DEVELOPMENT APPLICATION ASSESSMENT REPORT

Application Number:	DA2020/0567
----------------------------	-------------

Responsible Officer:	Catriona Shirley
Land to be developed (Address):	Lot 6 DP 514865, 6 Bellevue Place NORTH CURL CURL NSW 2099
Proposed Development:	Alterations and additions to a dwelling house including swimming pool
Zoning:	Warringah LEP2011 - Land zoned R2 Low Density Residential
Development Permissible:	Yes
Existing Use Rights:	No
Consent Authority:	Northern Beaches Council
Land and Environment Court Action:	No
Owner:	Richard Charles Hodgson Pilling
Applicant:	Richard Charles Hodgson Pilling Jill Pilling

Figure 1: Encroachment of the existing dwelling house (and additional works) into the rear setback area shown in green.

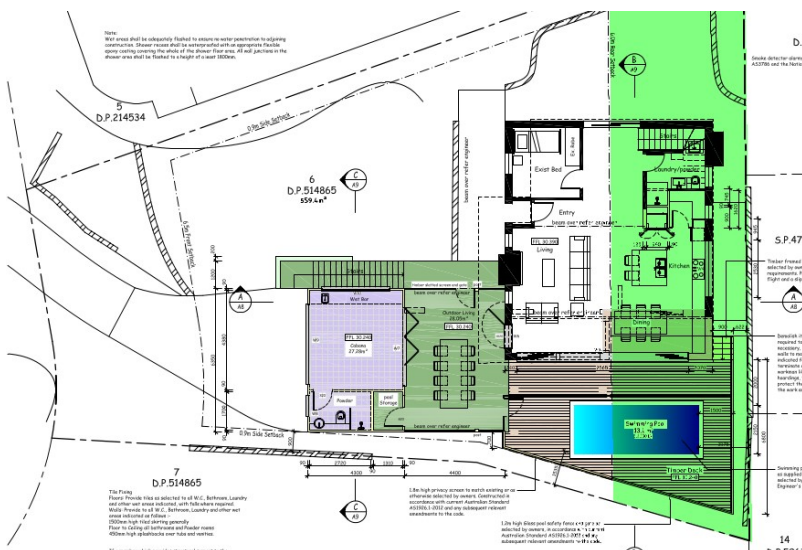
The proposal includes the replacement of the approved concrete terrace area (Building application BA5003/7648) that currently sits 0.622m from the rear boundary. The new decking terrace will mimic the existing non-compliant rear setback.

The proposal also involves a first floor terrace that displays a non-compliant 1.5m setback from the eastern rear boundary.

It is important to note that full compliance with the rear setback control is severely constrained by the existing dwelling house location. The existing dwelling is setback into the site and subsequently encroaches the rear setback area, as shown in figure 1 below.

However, whilst there application seeks to mimic existing rear and side setbacks, there is an opportunity in this application to improve the privacy impacts to the surrounding sites as detailed below.

The proposed decking (replacing the existing terrace) is elevated which presents overlooking opportunities. Whilst, the plans indicate that the existing setbacks will be provided to the surrounding neighbouring sites, improvements through the incorporation of privacy screens along the eastern edge of the decking will be conditioned to prevent downward viewing into the surrounding neighbours private open space areas.

The upper floor terrace is situated approximately 1.5m from the side boundary of No. 40 Griffin Road. The proximity to the eastern adjoining site means overlooking impacts are increased due to the elevated aspect of the subject site. In this respect, the balustrade along the eastern edge of the terrace has been replaced with a 1.65m louvered screen to prevent downward viewing from within the balcony area. This ensures that the proposal would adequately maintain the existing level of privacy between dwellings.

Direct overlooking is also evident from the south-east area of the decking. As a result, it is proposed to re-align the proposed pool fencing/balustrade across the deck area to reduce the usable area of the decking. This will provide an acceptable solution to the privacy impacts this section of the deck creates. It would enable the retention of a high amenity outdoor area for the proposed development, whilst maintaining privacy for the neighbouring dwellings.
